**ORIGINATION FORM**

Proposed Revisions to a Standard Plans Index  
(Please provide all information — Incomplete forms will be returned)

Index Number: 455-130

Index Title: 30" CFRP & SS Prestressed Concrete Piles

STRAND PATTERN

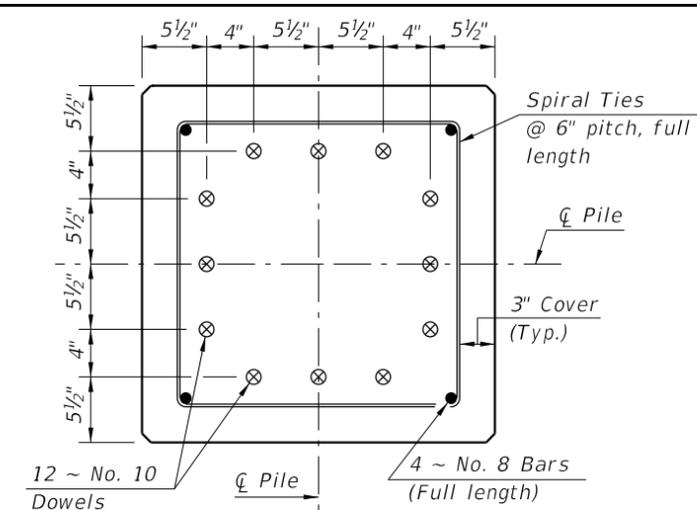
Added 0.6" HSSS strand

- 32 ~ 1/2" Ø, HSSS at 26 kips
- 24 ~ 0.6" Ø HSSS at 35 kips
